## **Urgent Field Safety Notice** – risk of device unexpected shutdown

### **AquaVENT® FD140i Gas Flow Driver for CPAP and HFOT**

Product codes AMFD140i-UK, AMFD140i-EU, AMFD140i-UK2, AMFD140i-EU2

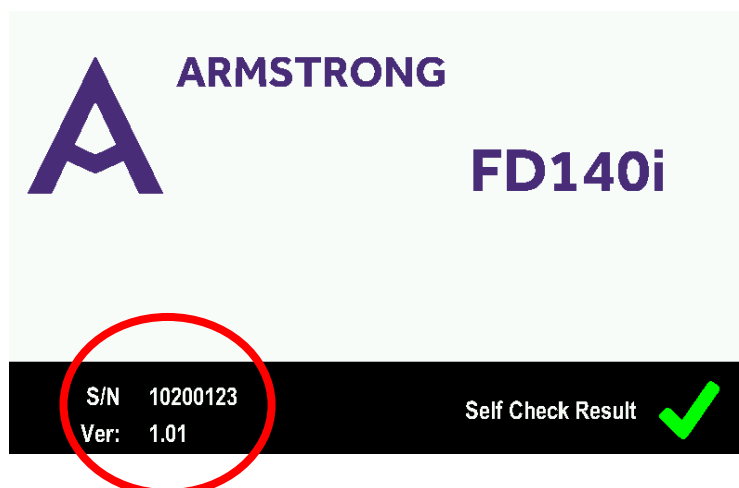
All devices having software version 1.01 will be updated with new software release version 1.02. Our representatives will make contact with you soon to arrange for the new release software to be installed. The current software running on your device is displayed during device switch ON at conclusion of the Self Check. Please see graphic, *right*.
